Project name:
Palo Alto Rail Program Management

Date:
December 17, 2019 (Update from 12/5 version)

Memo

Subject: "New Ideas" from XCAP Technical Working Group

Alexis - Charleston Underpass and Roundabout Layout

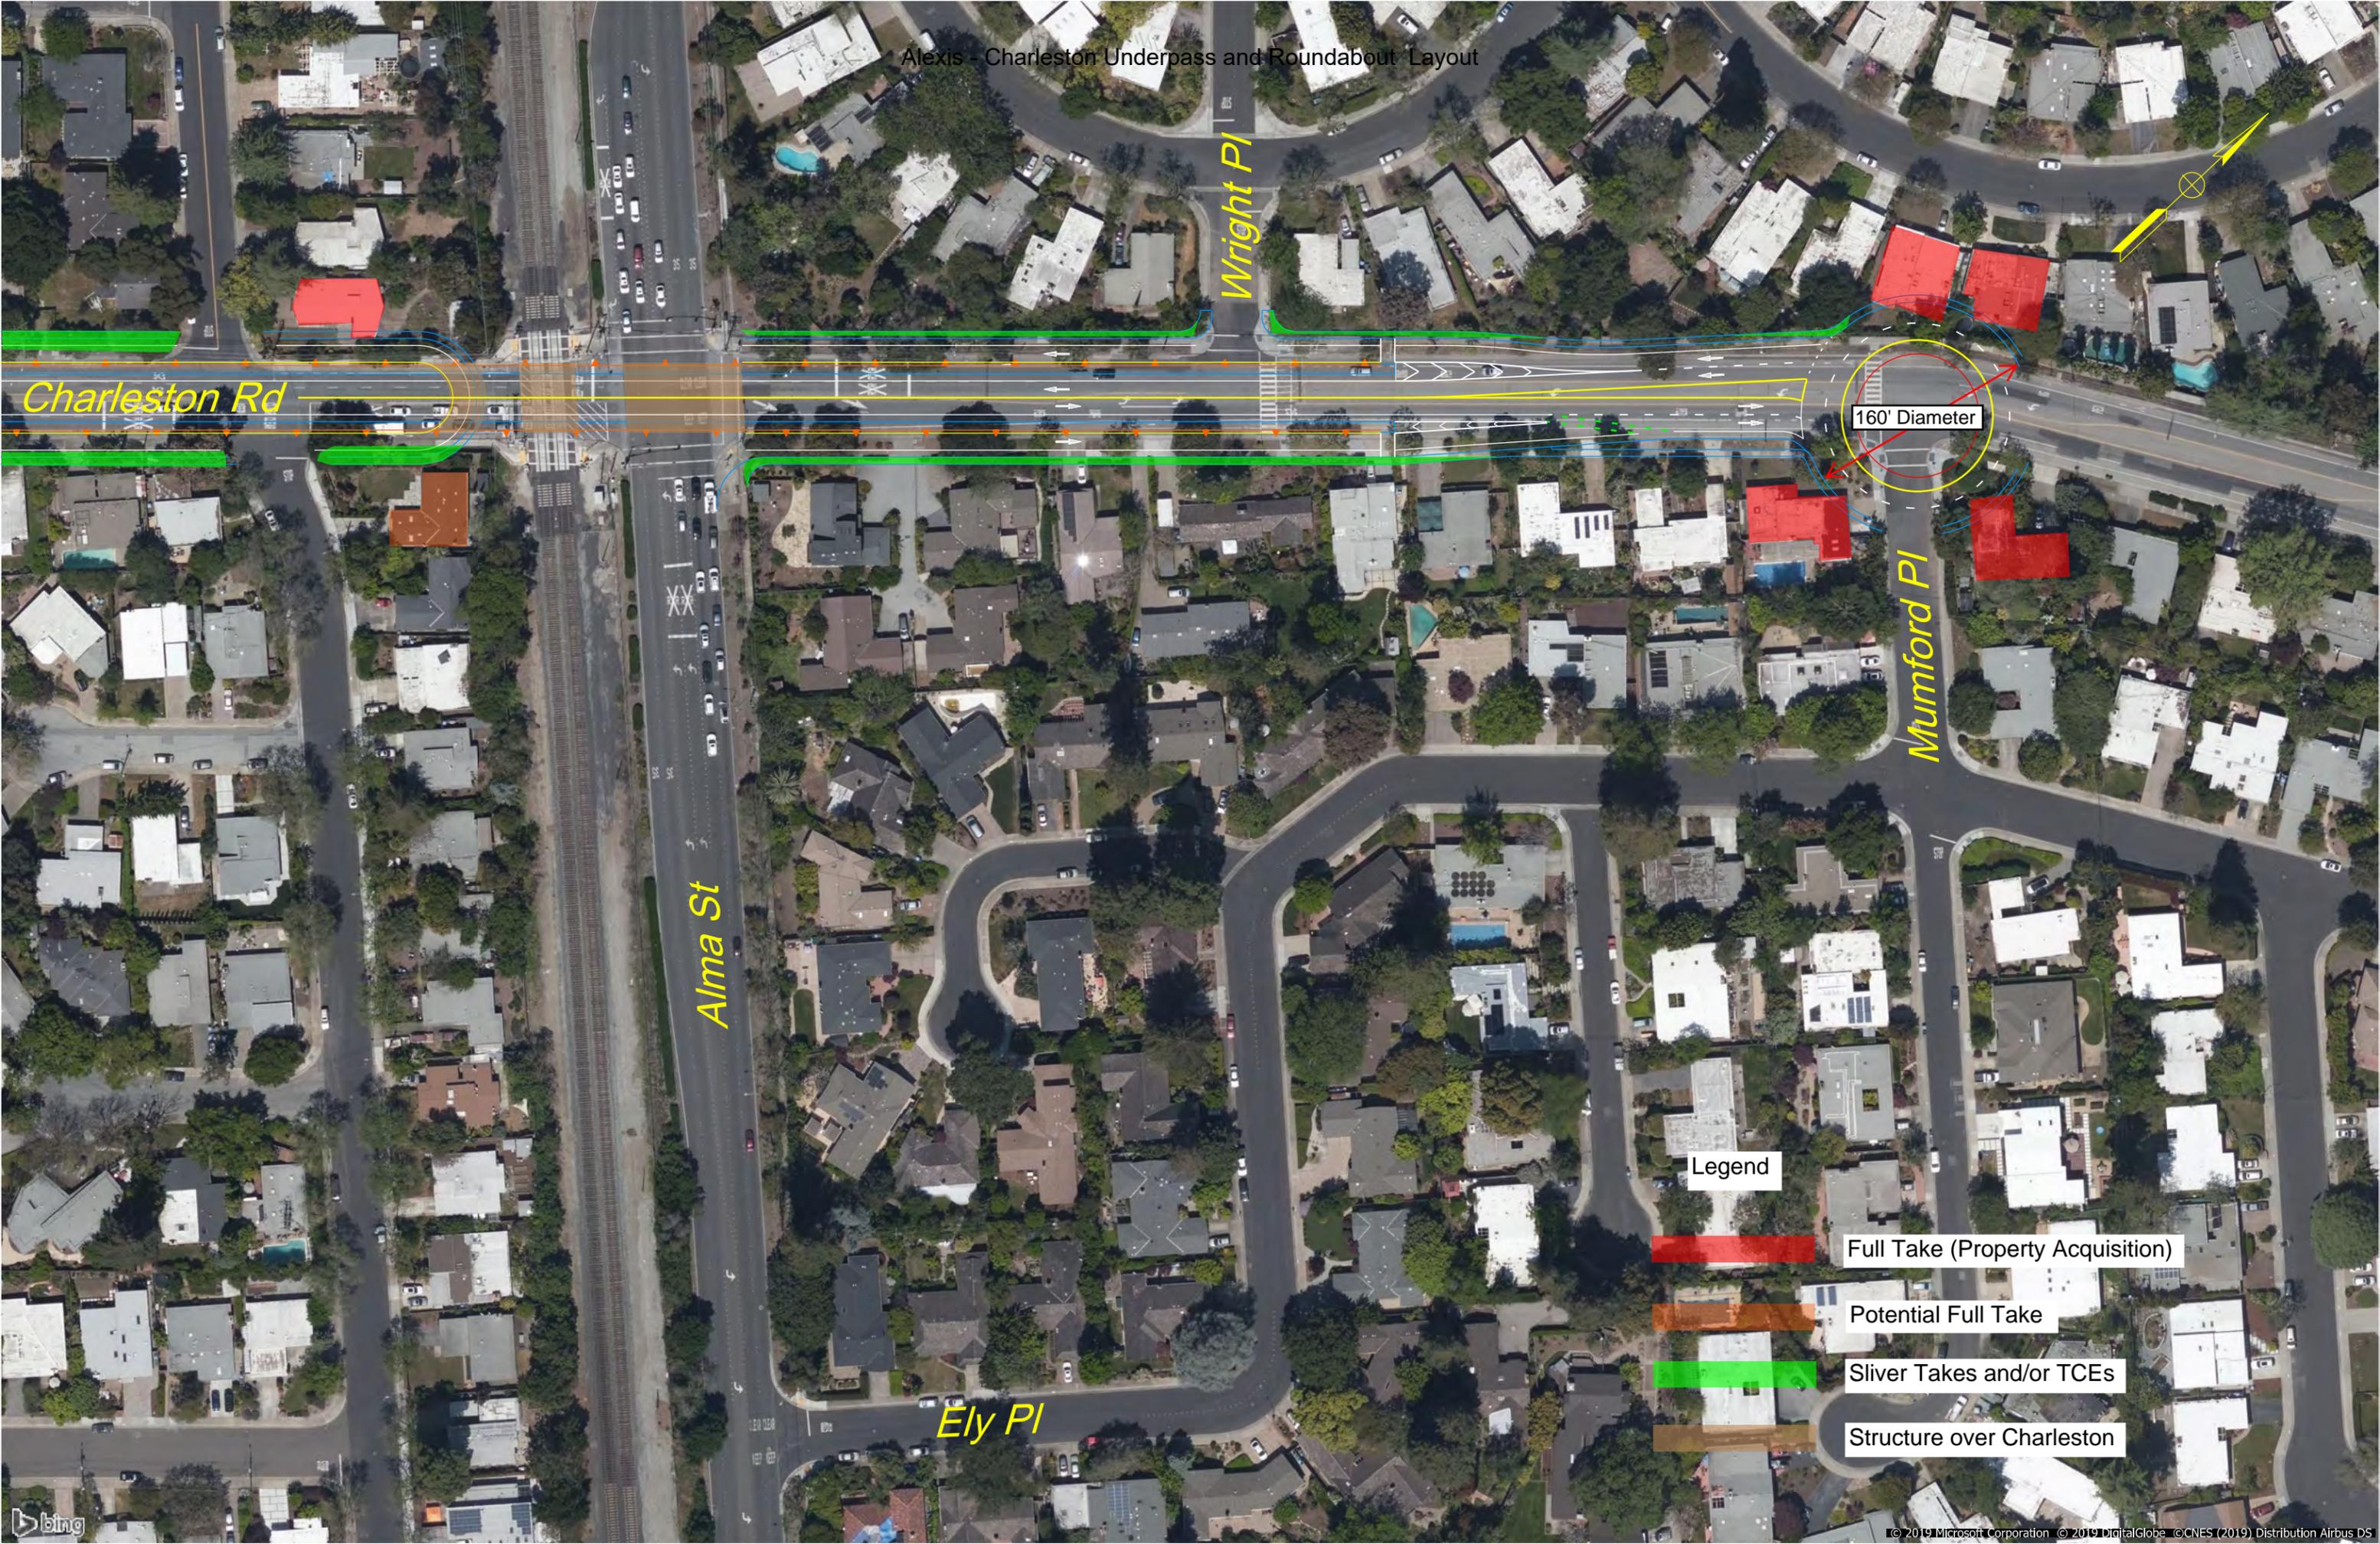
- The presentation infers no property impacts, but the width needed to accommodate the turning movements (the u-turn bay, for example) for truck/buses will likely require sliver takes (at the very least) or complete property acquisitions. A 2-lane roundabout (~172-foot outside diameter, including sidewalks) would be required to accommodate the additional traffic and turning movements. The roundabout's footprint would require full property acquisitions.

- A circuitous route is proposed for EB vehicles on Charleston and Meadow.
- Traffic on NB and SB Alma St destined for El Camino Real and other locations on the west side of the tracks would also have to traverse a circuitous route. In the NB direction, drivers will likely opt for Ely PI to access Charleston via Mumford PI to avoid any backups on Alma St, thus generating more traffic on residential streets.
- Road geometry would have to be hashed out to ensure queuing of vehicles (for the u-turn movement, for example) does not impact through movements.

- The "split" of Meadow and Charleston will create a conflict between peds/bikes and motor vehicles, i.e., peds would be on the outside of the road approaching the railroad, but then cross one lane of (moderately high speed) traffic to get to the inside lane (to enter the underpass section of M/C).
